L-2009-085
10 CFR 50.54(f)

Florida Power & Light Company
St. Lucie Unit 2
Docket No. 50-389

Subject: Response to NRC Request for Additional Information

**Individual Responses to NRC RAIs for FPL Generic Letter GL 2004-02
Supplemental Responses, Dated 02/27/2008 and 06/30/2008**

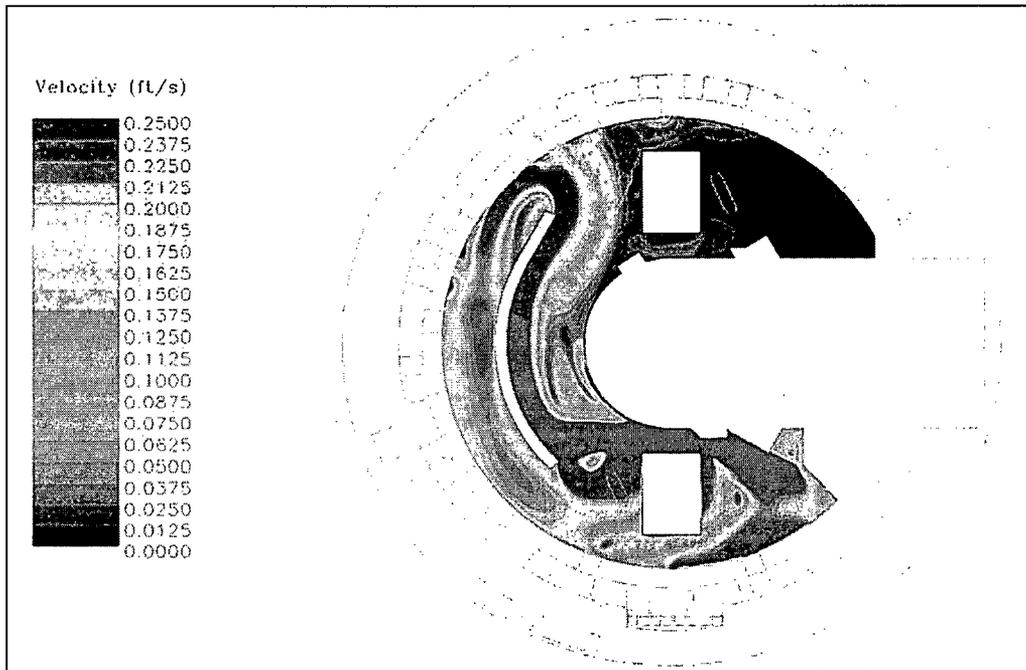
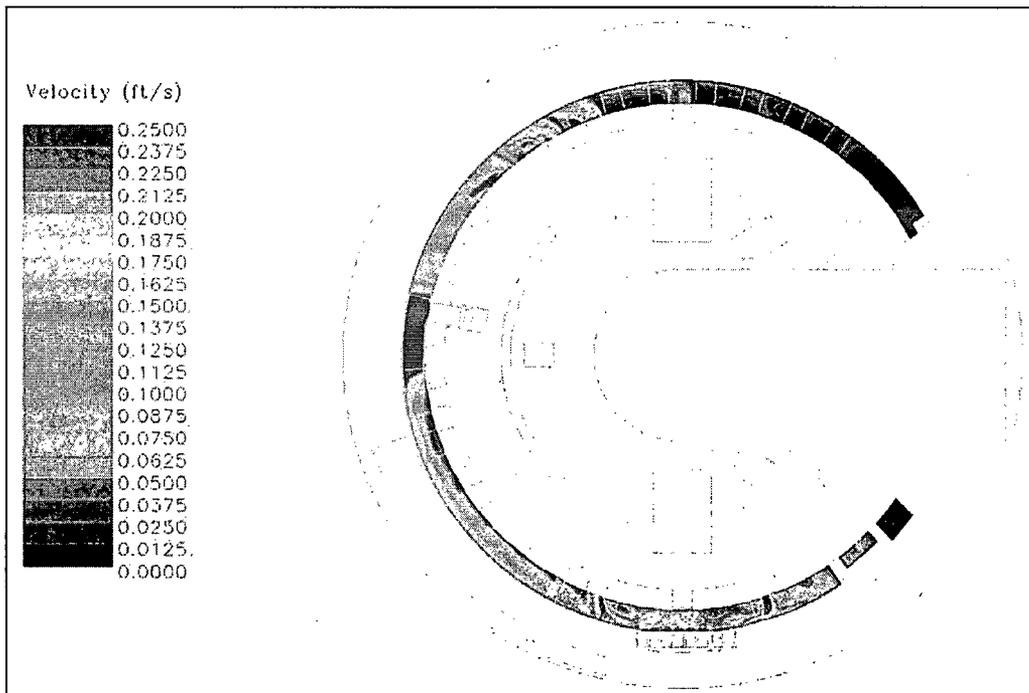
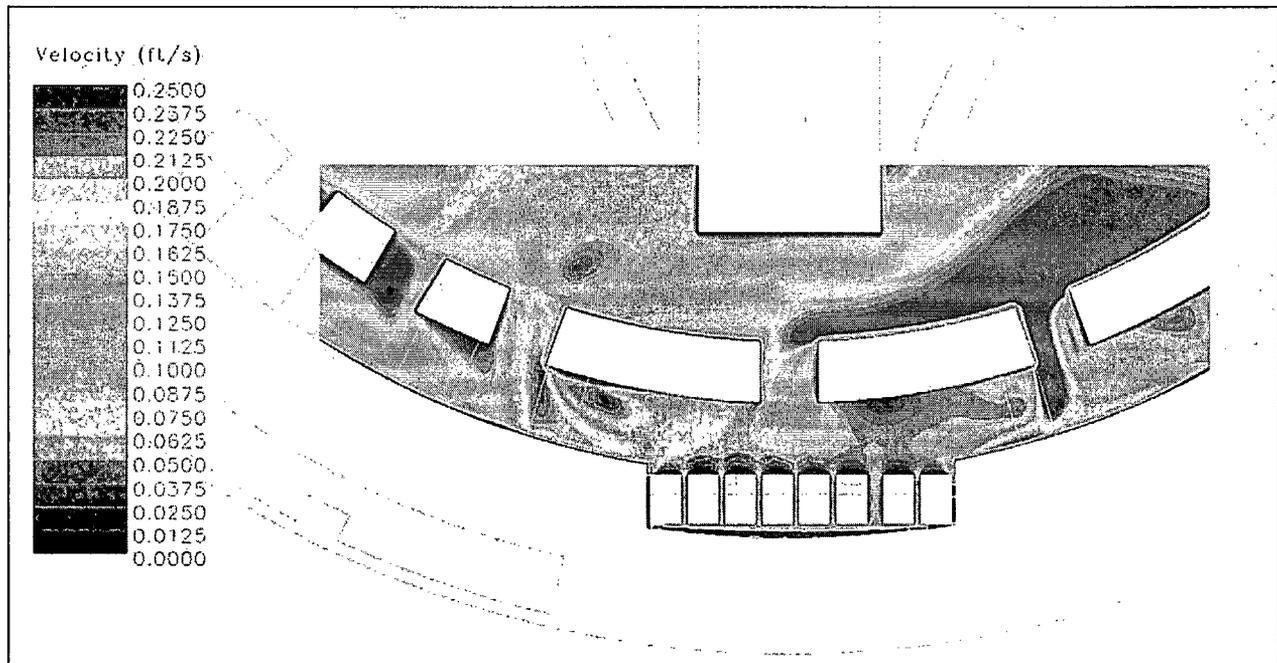
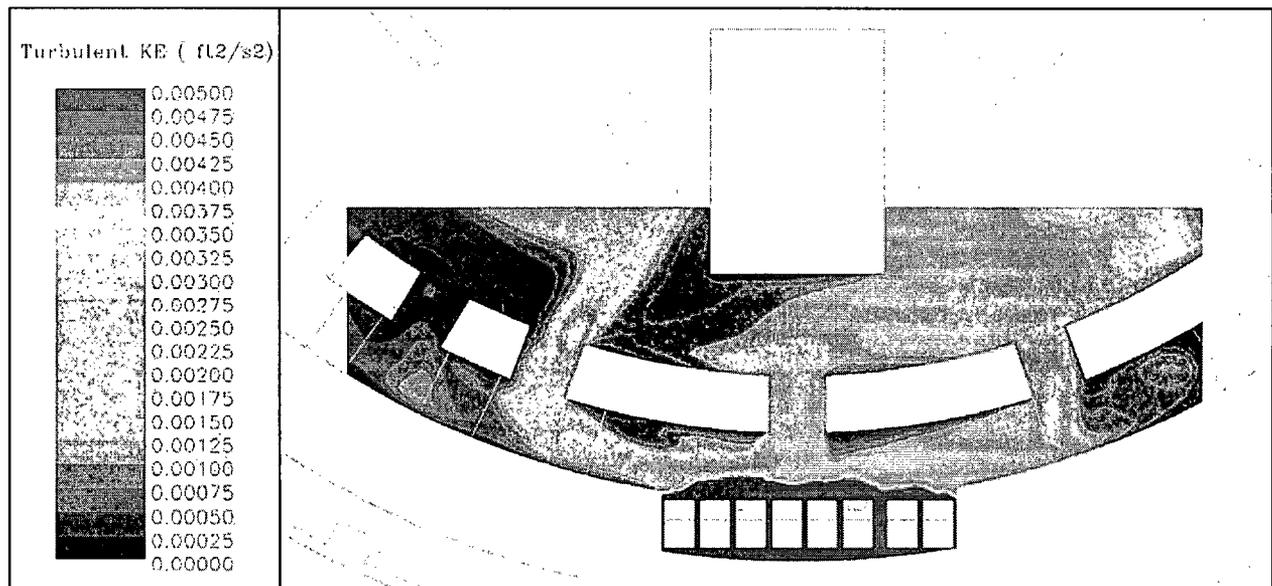
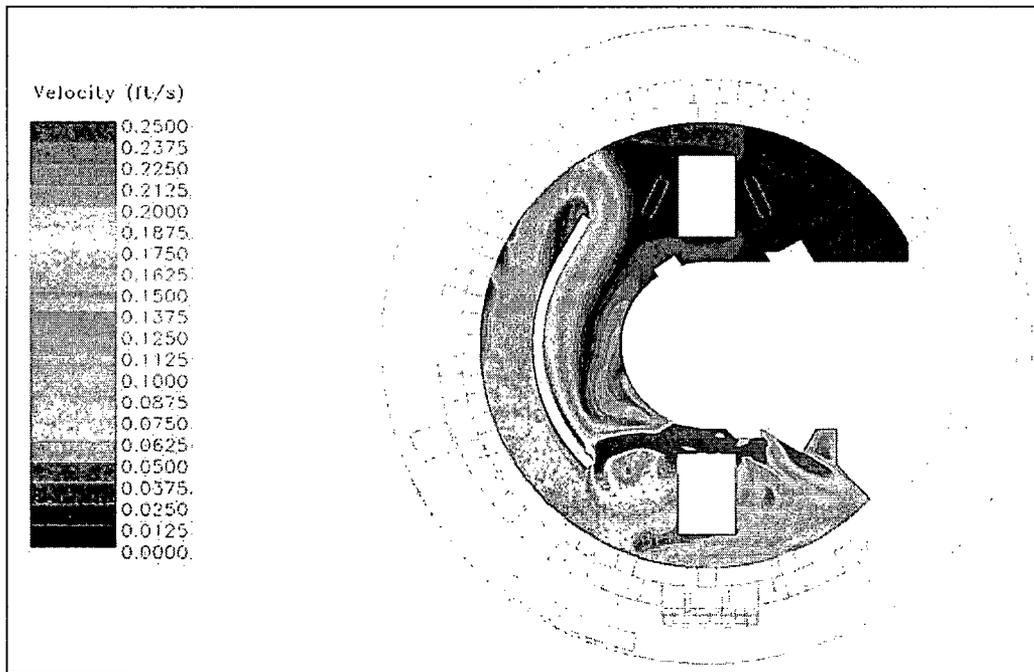
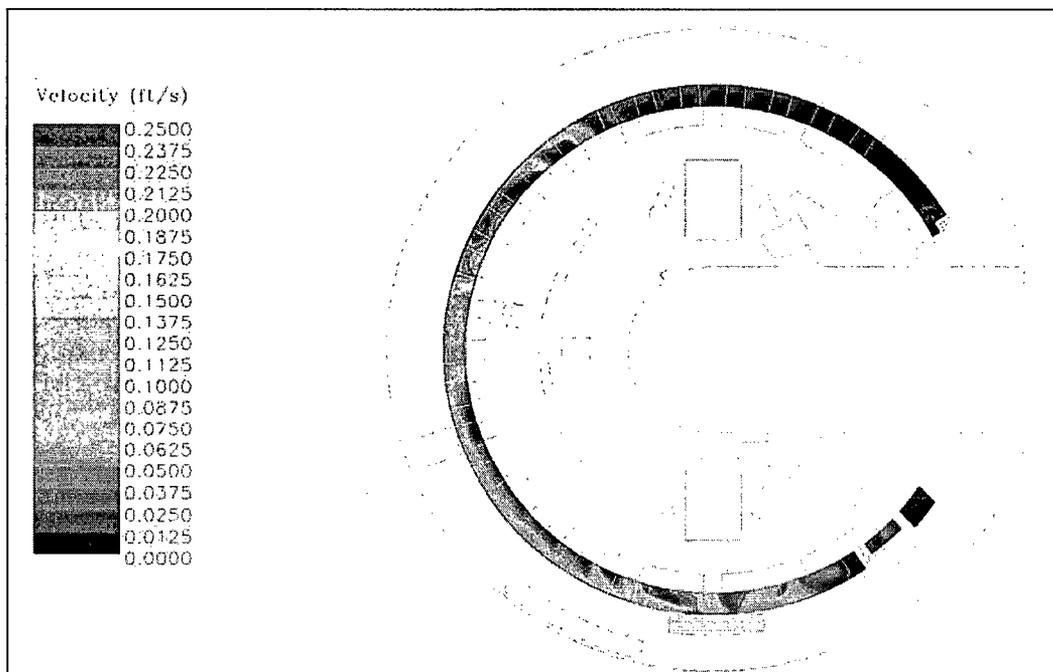
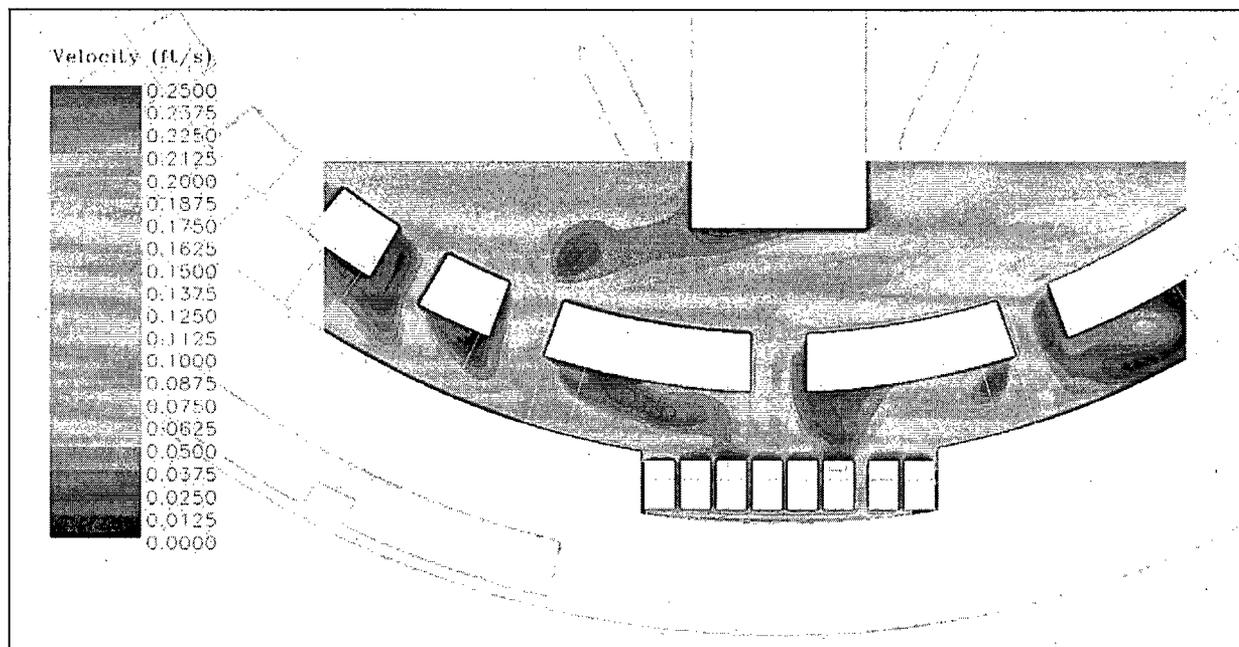
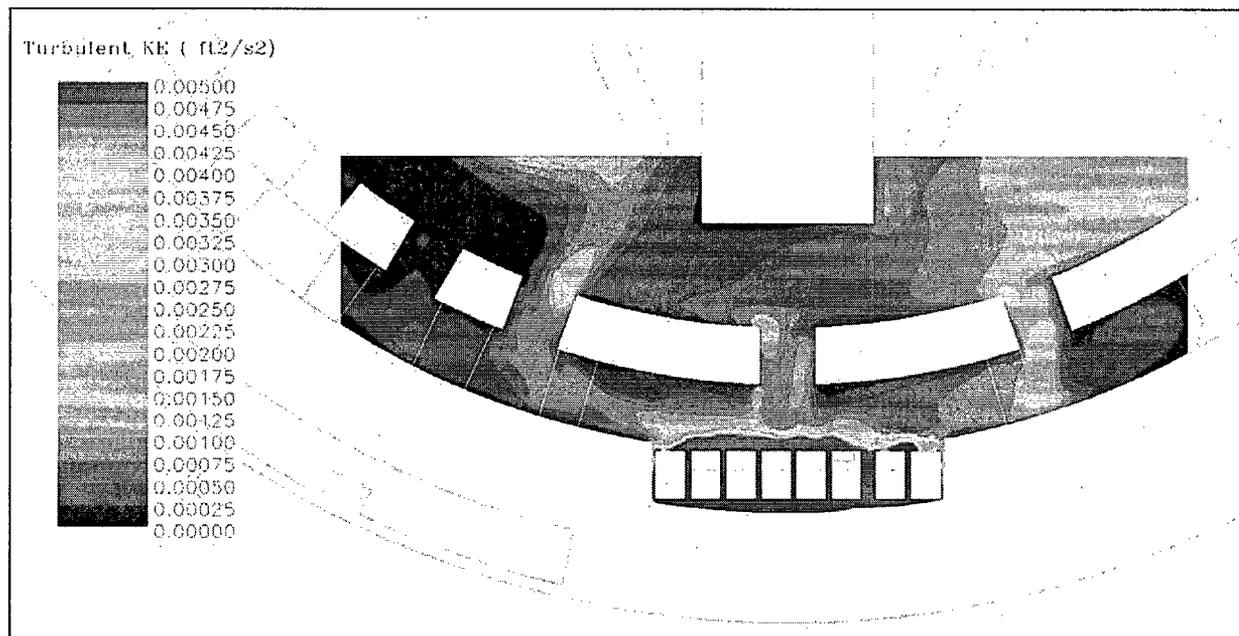
RAI-6: Provide a contour plot of the velocity for the containment pool inside the bioshield wall. Provide a contour plot of the velocity in the emergency core cooling system (ECCS) trench. Provide a close-up plot of the velocity and turbulence contours in the region of the strainer and its immediate vicinity. Provide a table of the head loss test flume average velocity as a function of distance from the test strainer and identify the turbulence level simulated in the test flume.

RAI-6 RESPONSE: The contour plots, Figures 6-1 through 6-8, requested are shown below. Additional turbulence, above that which is associated with the shear in the flow as the water approaches the strainer in the test flume, was not implemented. Tables 6-1 (LPSI failure to trip case) and 6-2 (Design Flow case), test flume velocity vs. distance from strainer module, are also shown below.

Figure 8-1: Streamlines for Scenario: Particles Released from Sump

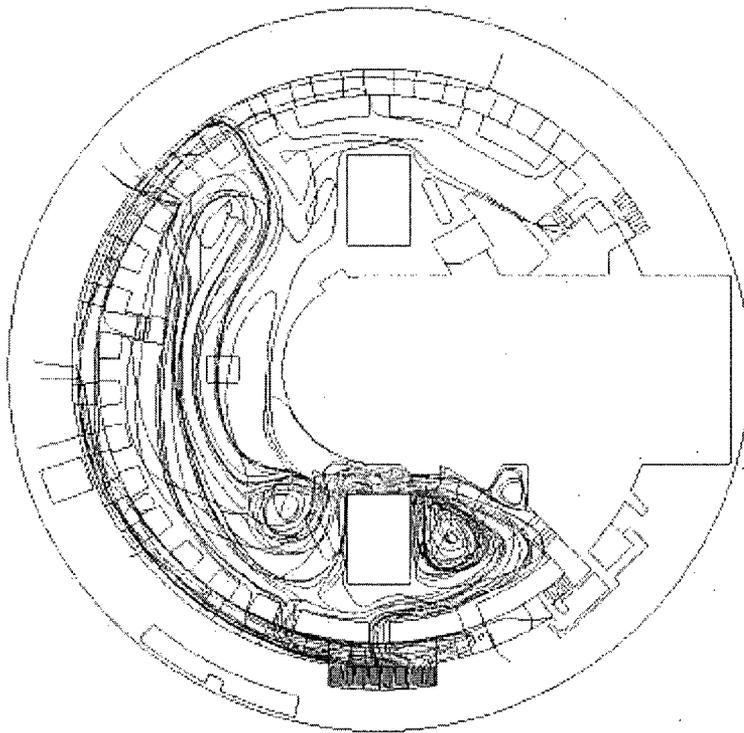
RAI 8: Provide the general methodology used to determine the average flow to the strainer modules. In doing so, provide added detail concerning how the flow velocity in the ECCS trench approaching the modules from each side of the modules was “averaged” with the flow approaching from the shield wall openings in front of the modules. Identify the “four flow streams” discussed on page 20 of the supplemental response.

The four flow streams are the flow paths to the strainer. Refer to Figure 8-1 below. The flow approaches the strainer from four directions, from the trench on each side of the strainer and from the two nearest openings in the SBS wall.

Figure 12-1: Small Debris Logic Tree for Blast, Wash Down, and Pool Fill

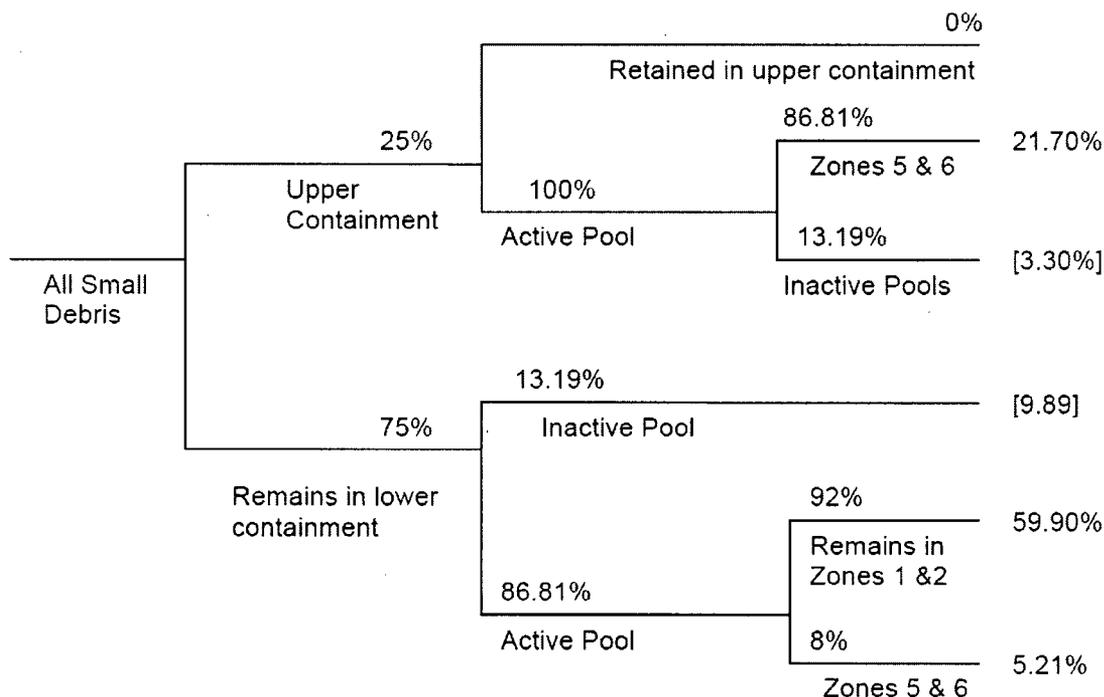
RAI-12: Describe the methodology and technical basis for the conclusion that 23% of the calcium silicate debris settles in the containment pool. State the size distribution of the calcium silicate that is assumed to settle in the containment pool.

RAI-12 RESPONSE: The basis for determining the total percentage of calcium silicate debris that settled out in the containment pool is documented in “St. Lucie 2 Nuclear Plant (PSL2) – Debris Transport” calculation. Based on the blast, washdown, and pool fill phases 13.19% of the calcium silicate debris is sequestered in inactive containment sump volumes.

Figure 15-1

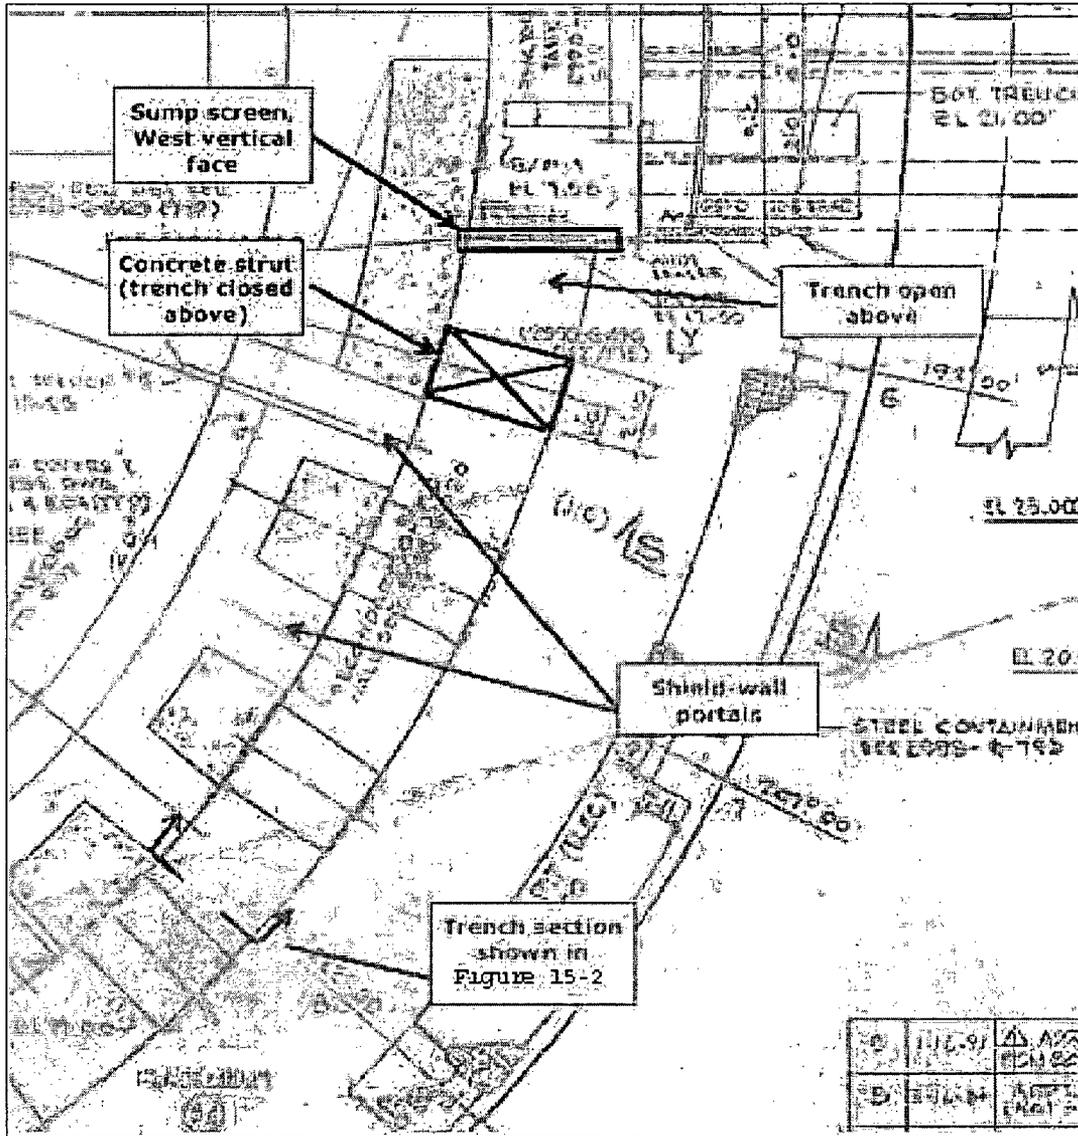
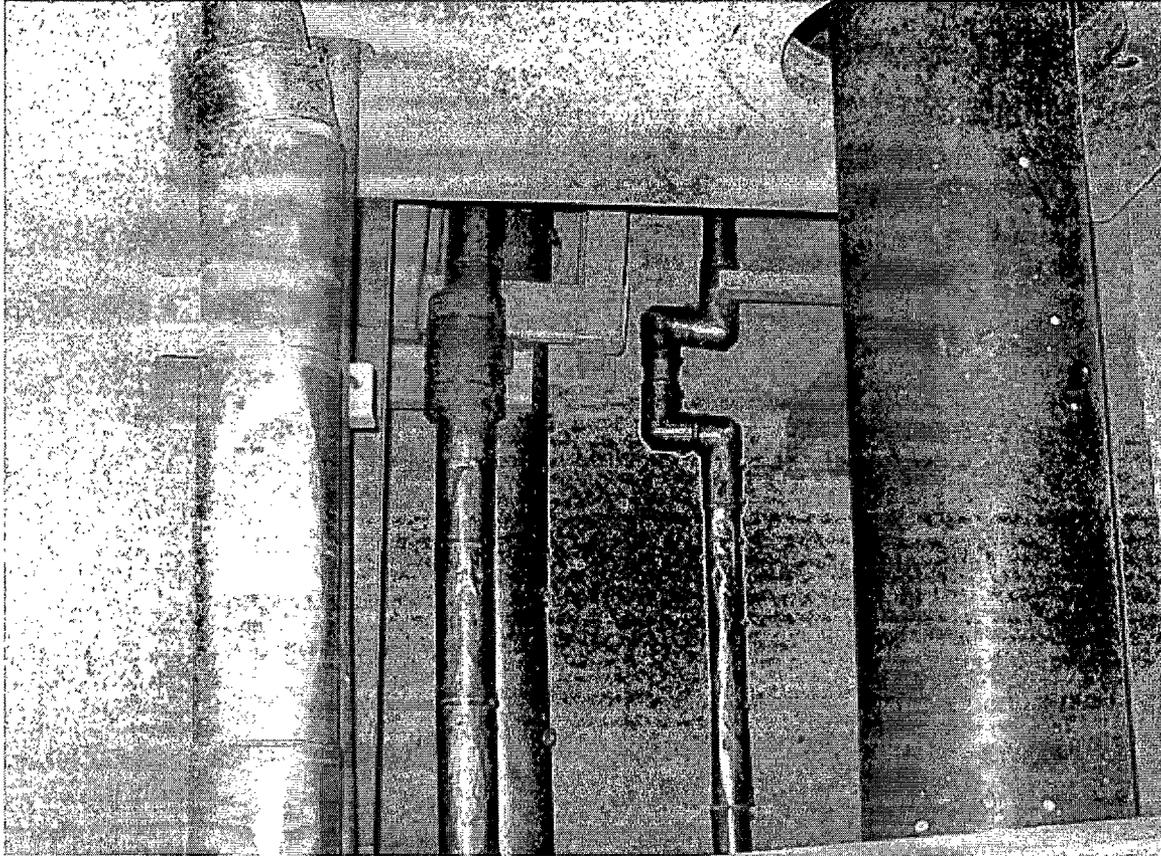
RAI-15: In the upstream analysis, the supplemental response states that chokepoints in the ECCS trench are not an issue because large pieces of debris will not enter this trench due to the presence of trash racks around the bioshield wall. However, the supplemental response did not address the potential for large debris to be blown into upper containment and then washed down by containment sprays outside of the bioshield wall downstream of the trash racks. Provide a basis to justify that blockage in the ECCS trench will not occur in light of the phenomenon discussed above.

1. The ECCS trenches are located around 270 circumferential degrees of containment just outside of the SBS wall (see figure 15-1 below). Much of the trench is covered by grating or floor which would restrict the intrusion of large debris. Should a portion of trench be partially or totally blocked at some point, numerous alternative flow paths to the ECCS strainers remain.

4. Since the ECCS trenches contain some piping supports and equipment, it is very improbable that debris of such size and exact geometry could pass into and completely or significantly block a trench due to interfering piping or equipment (see figure 15-2).

7. Finally, the smallest cross section of the ECCS trench is 5 ft. wide by 7 ft tall. Such a cross section would require quite a large perfectly placed section of debris to disrupt flow. The trench cross section becomes deeper as the strainers are approached (see figure 15-2 for a photograph of the trench).
